Product Change Notification

Changes to HPH pin carrier

29th June 2026

Appendix A – Details of design change

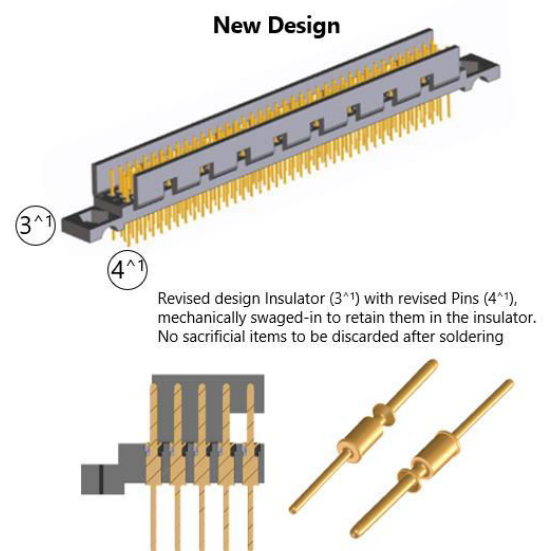
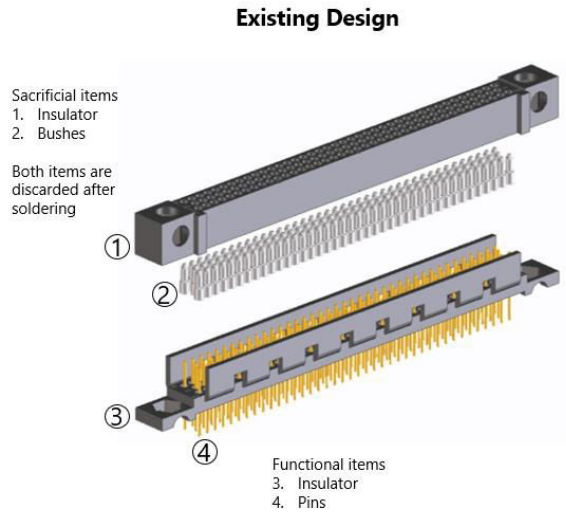
The following changes to the HPH pin carrier were undertaken to improve the production process. Our design authority has approved this change.

The current design uses sacrificial components with PTFE bushes to hold the pins during the soldering process; these items are subsequently discarded after soldering process. Other than the fact that the part is a waste, PTFE is identified as 'forever chemical' and several manufacturers have indicated plans to stop production in coming years. The design change done to the insulator together with the pins will ensure the pins are mechanically swaged directly into the insulator. This means the pins are retained inside the insulator before and during soldering process without the need for separate sacrificial bushes or a temporary insulator. Please refer to Appendix A, which outlines the details of this change.
